AGENDA
Molalla Planning Commission
6:30 PM, September 1, 2021

Date: August 25, 2021 for the September 1, 2021 Planning Commission Meeting

Proposal: Site design review for the change of use/occupancy of an existing laundromat to a convenience store.

Project	Molalla	Sheet	A1/4
Date	10Dec2020		
Scale	as noted

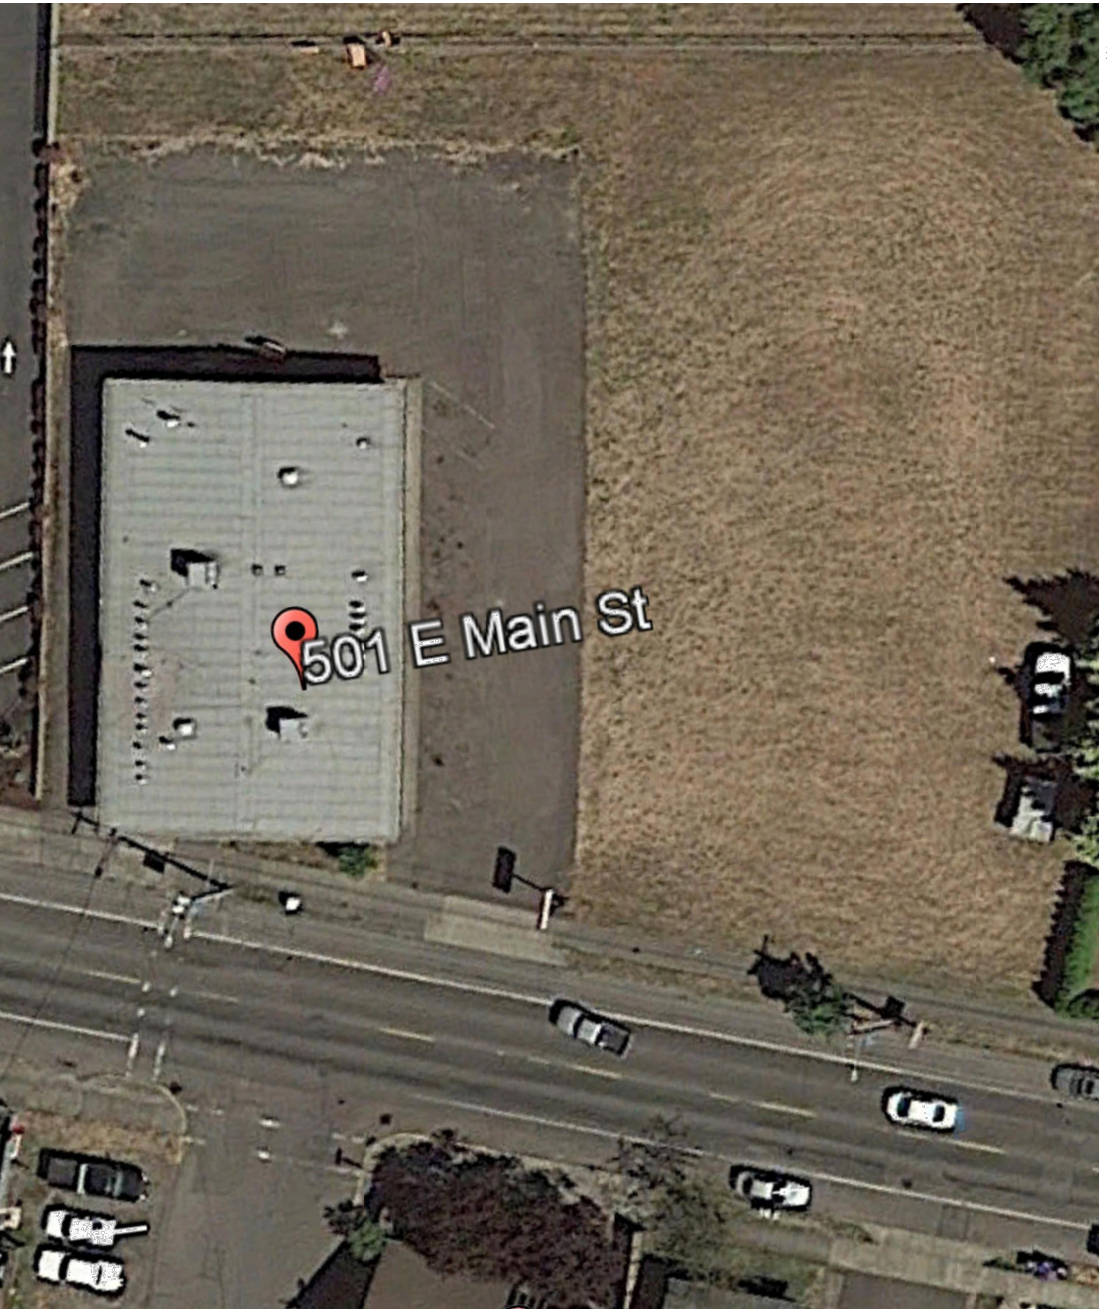
Findings: This criterion is met subject to conditions of approval. The Oregon Department of Transportation (ODOT) is the applicable roadway authority for OR-211. Site access to the state highway is regulated by OAR 734.51. As shown on Sheet A1 of the Applicant’s submitted site plan, the Applicant proposes to close the existing ingress/and egress accesses from OR-211 to the site and will take access from a new to the site shall be taken from a new access from OR-211 on the eastern portion of the property. The new access point was chosen per ODOT recommendation for safety by removing the existing offset between the access and Lola Ave and to create room for the required left turn pocket.

Findings: The Applicant's submitted site plan shows a paved driveway from the new access along OR-211. Criterion is met.

The Applicant's submitted site plan shows a 30' driveway width. Molalla Public Works Detail Drawing R-1095 Commercial Driveways requires a driveway width between 30-40

Findings: The Applicant proposes to modify an existing parking lot. The existing lot has no landscaped areas and does not meet the above standard of 10% landscaping coverage. The Applicant's submitted site plan adds 110 sqft of landscaped island, including one tree. Per 17-1.4.030, A the Applicant's proposal meets requirements for alterations of a non-conforming development. The proposal does not increase the non-conforming development by more than 50% and proposed modifications to the lot move the parking area towards conformity with this standard. Additional modifications to the subject site in excess of 50% will require the entire lot to be brought to full conformity with this standard.

The Applicant's submitted site plan shows 12 (twelve) parking spaces. The Applicant's submitted site plan shows one added tree to the parking area, meeting the requirement for minimum one tree per 12 (twelve) parking spaces.

- m. The Applicant shall confirm that parking stall curb widths are greater than or equal to 8.5' on submitted building plans (MMC 17-3.5.030 F).
- n. Parking shall be provided consistent with ADA requirements (MMC 17-3.5.030 H).

- o. The Applicant shall show bicycle parking accommodating at least three (3) bicycles on their submitted building plans (MMC 17-3.5.040).
- p. Applicant will be required to resubmit traffic analysis accounting for all trips through the intersection in the AM and PM peak hours, provide signal warrant analysis for all warrants, and apply a population of 10,000 and over to the analysis. The analysis must be conducted by a Professional Engineer registered in Oregon. TIA will not be approved until the city receives concurrence with ODOT traffic that the TIA is correct. If the change in use meets all warrants at the OR 211/Leroy intersection, then the applicant will be required to design and construct the signal. If the change in use does not meet signal threshold, then no signal improvements will be required. TIA resubmission shall be prior to submission of civil plan review and building permit authorization review (MMC 17-3.6.020).

SITE ANALYSIS MAP
 scale: 1" = 40'

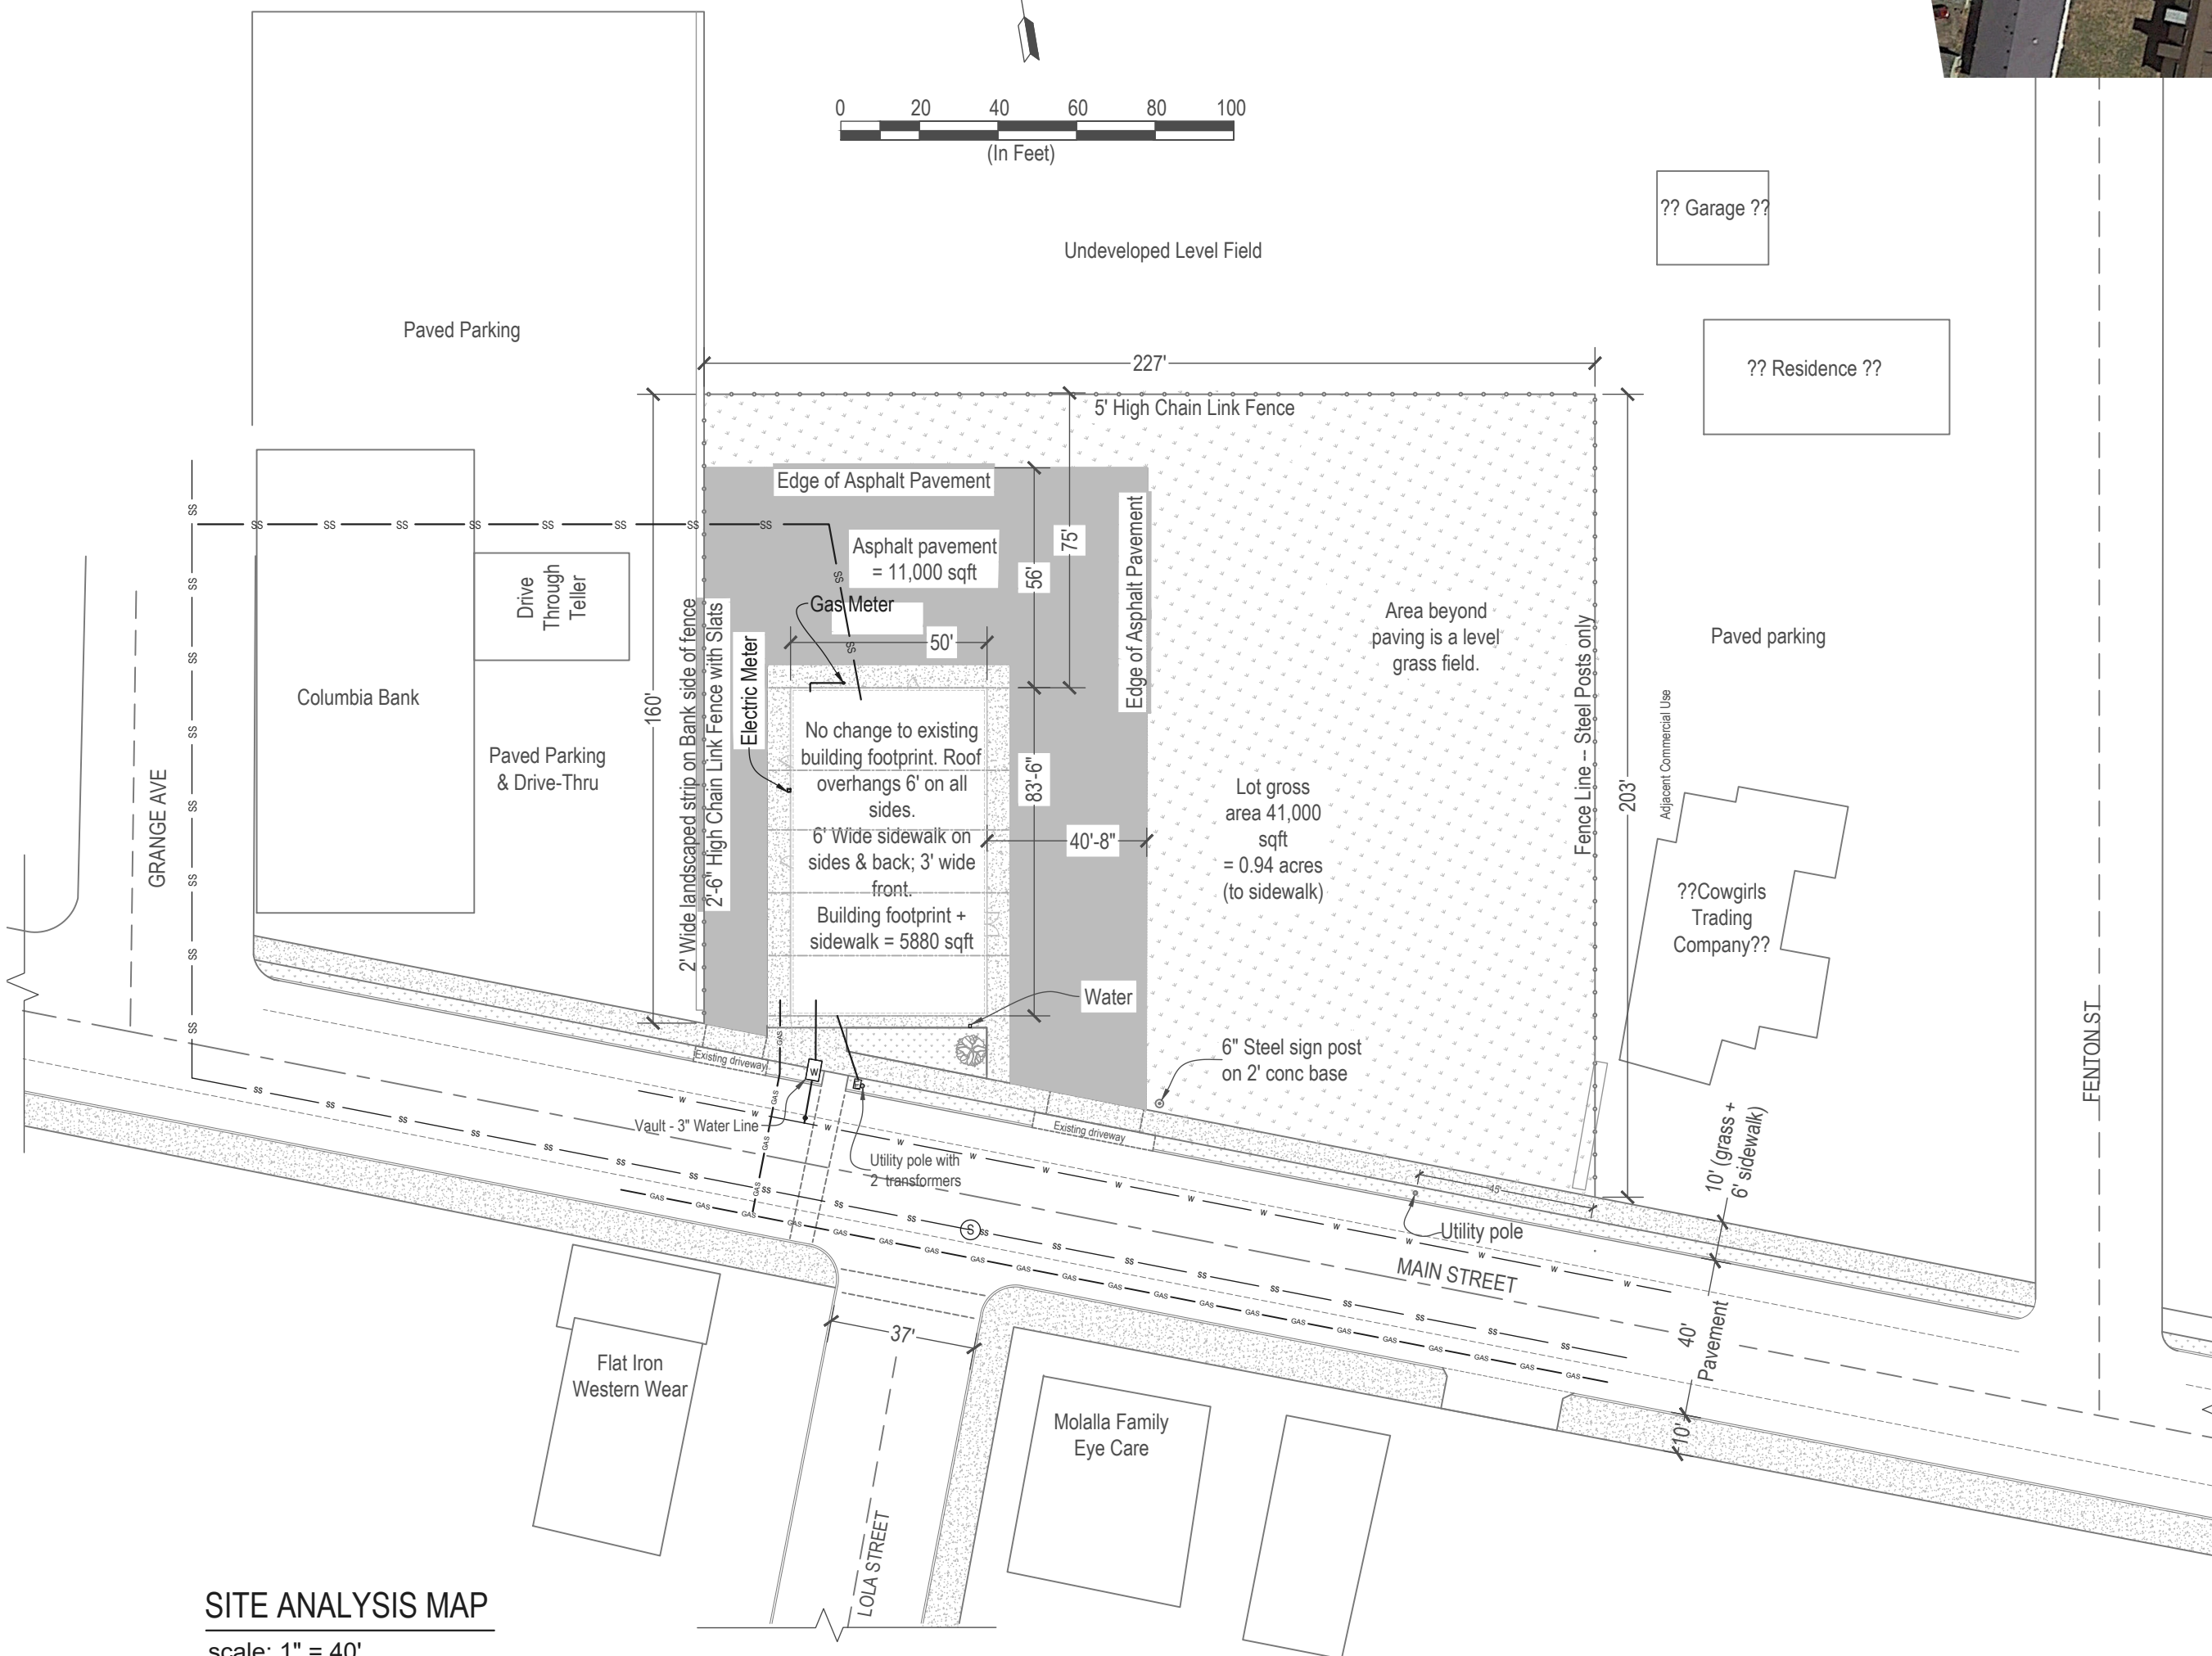
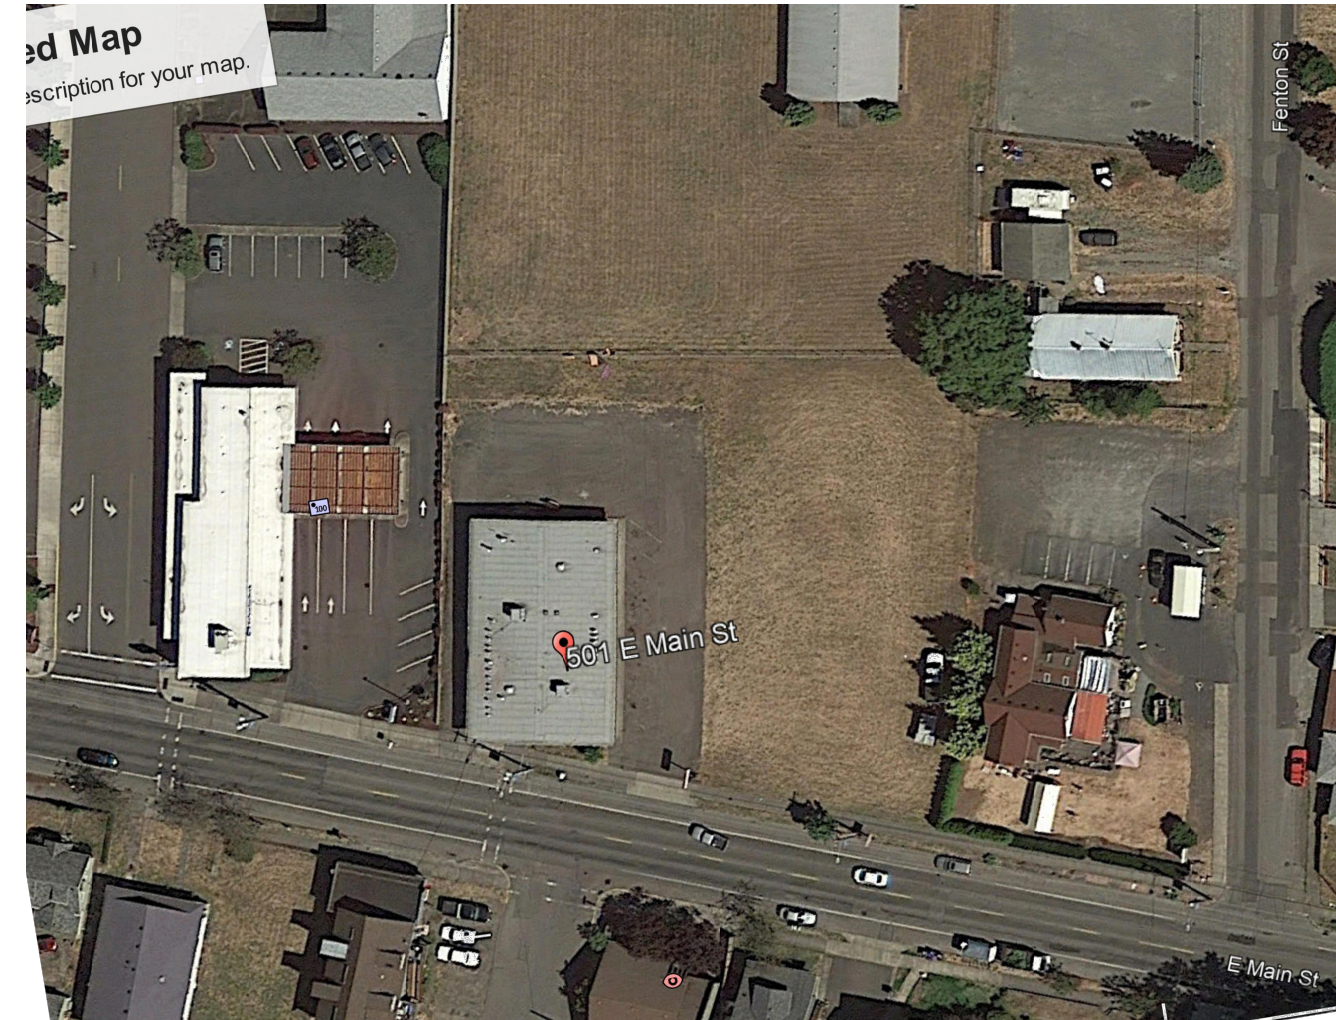
Sheet A4/4 Site Analysis Map is add to the original three sheet submission.

- a. Sheet A4/4 shows both an aerial photo and a matching drawing of the existing lot with details. Boundaries on three sides are fences with the Main Street sidewalk on the fourth side.
- b. This is a flat lot with discernable gradient or topographic features. If and when the balance of the lot is developed, stormwater management will require drainage organization.
- c. There are no significant slopes on this property.
